Model Evaluation Report for Corrective Action Unit 98: Frenchman Flat, Nevada National Security Site, Nye County, Nevada

Revision No.: 1

September 2014

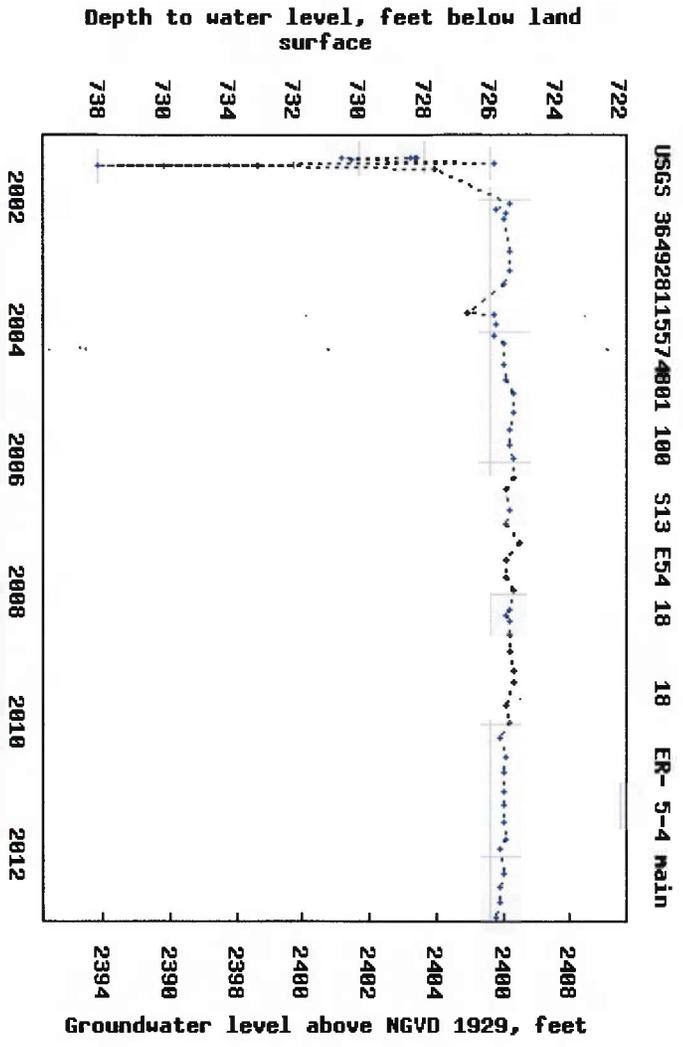
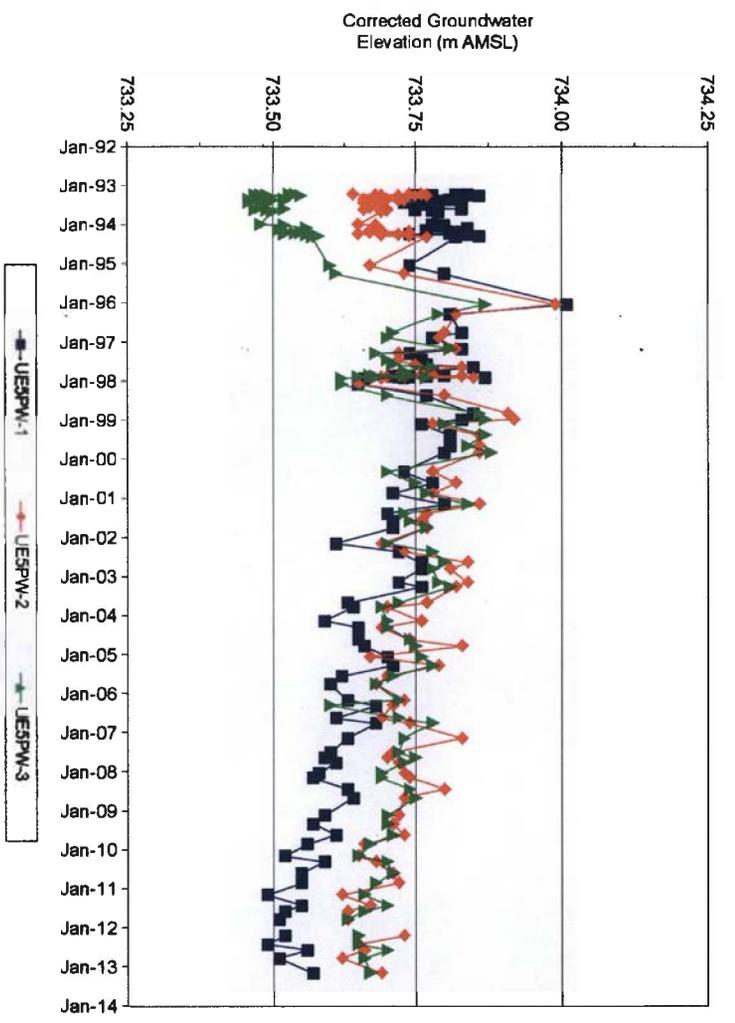
3. After review of a draft of the memorandum in August 2013, the NDEP made the following comment which was not addressed in the final memorandum attached to the above–referenced letter: In regards to the **Water-Level Measurement Frequency** section on Page 3, the reader has to look very closely at Figures 2 and 3 to observe the sampling frequency, which appears to be quarterly for the USGS wells and twice a year for the NSTec wells. It was stated in a meeting on February 6, 2014 with NNSA/NFO and NDEP personnel that the text would be revised and the figures would be landscaped and placed on separate pages to increase the clarity.

3. After review of the draft memorandum in August 2013, the NDEP made the following
    comment which was not addressed in the final memorandum attached to the above-
    referenced letter: In regards to the **Water-Level Measurement Frequency** section
    Page 3, the reader has to look very closely in Figures 2 and 3 to observe the sampling
    frequency, which appears to be quarterly for the USGS wells and twice a year for the
    National Security Technologies (NSTec) wells. It was stated in a meeting on February 6,
    2014 with NNSA/NFO and NDEP personnel that the text would be revised and the
    figures would be landscaped and placed on separate page to increase the clarity. *Refer to
    the Navarro-Intera (N-I) memo, Attachment 2, that contains the revised text and figures
    that are more legible and easier for the reader to discern the sampling frequency.*
